NOTICE OF PROPOSED CHANGE IN PROPERTY

Petition: x107-R

B						CONVERSION TO EASEMENT THE EAST/WEST PUBLIC ALLEY, 20 FT. WD. AND THE NORTH/SOUTH PUBLIC ALLEY, 18 FT. WD. IN THE BLOCK BOUND BY BELVIDERE, CAIRNEY, HOLCOMB AND GRATIOT AVE.	CITY OF DETROIT CITY ENGINEERING DEPARTMENT SURVEY BUREAU	
A							JOB NO. 01-01	
DESCRIPTION		DRWN	CHKD	APPD	DATE		DRWG. NO. X 107	
DRAWN BY		CHECKED		DATE				
DATE		APPROVED

PETITION NO. 107-R
 9100 GRATIOT LDHA LLC
 9200 GRATIOT AVE.
 DETROIT, MICHIGAN 48213
 C/O CLEOPHUS BRADLEY
 PHONE NO. 313 922-1435

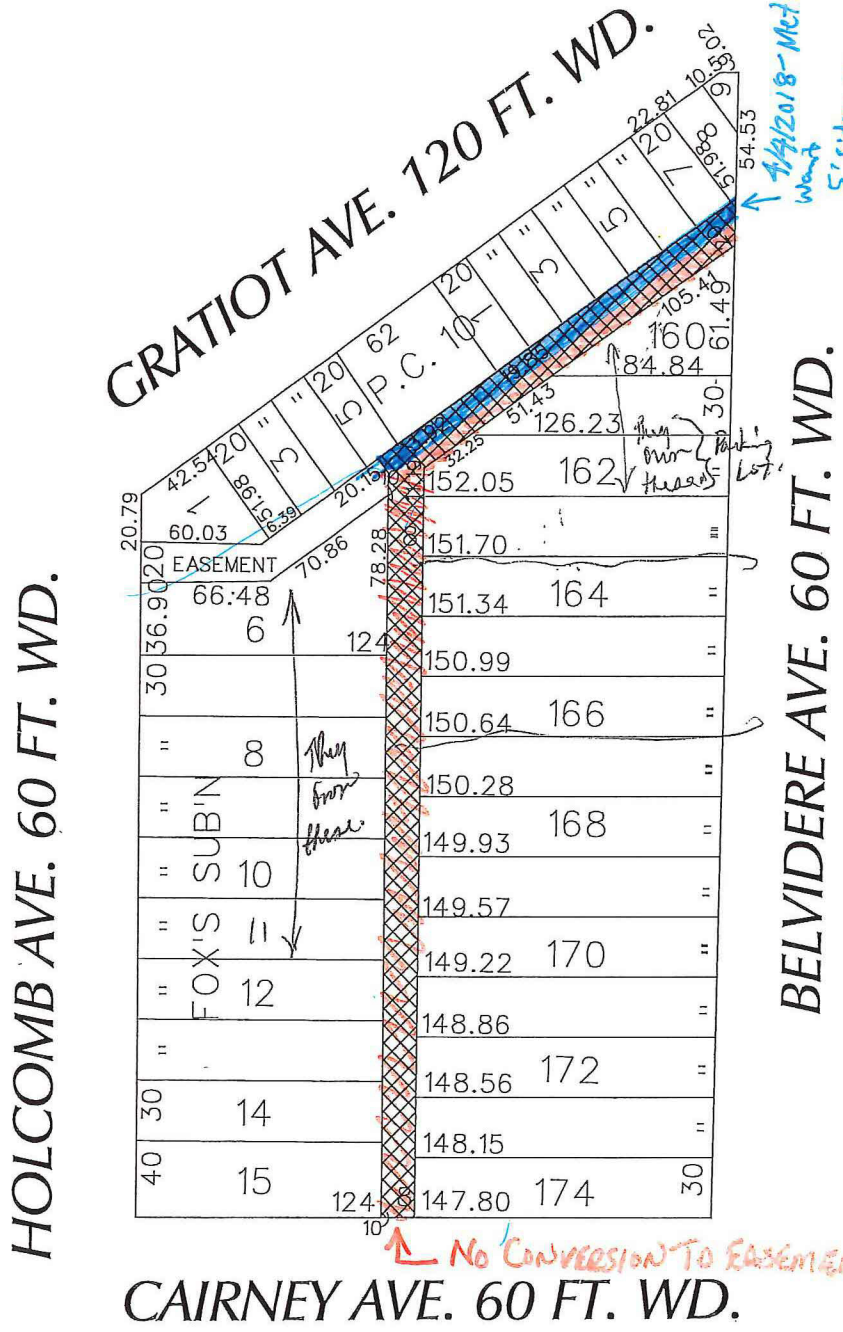
A CONVERSION TO EASEMENT FOR THE FIRST FIVE FEET DIRECTLY BEHIND THE BUILDING AT 9000 GRATIOT AVENUE FOR THE SIDEWALK IS ALLOWED. DTE ENERGY IS UNABLE TO GRANT CONVERSION TO EASEMENT FOR ENTIRE ALLEYWAY AS IT WOULD NEGATIVELY IMPACT THE RELIABILITY OF ELECTRIC SERVICE TO OTHER CUSTOMERS ON THE CIRCUIT SINCE WE WOULD NOT BE ABLE TO ACCESS OUR EQUIPMENT.

4/22/2018 - Met w/ customer want 5' sidewalk here (Rights behind bldg)
 4/22/2018 - This 5 foot South Alley is acceptable to DTE Energy for conversion to easement
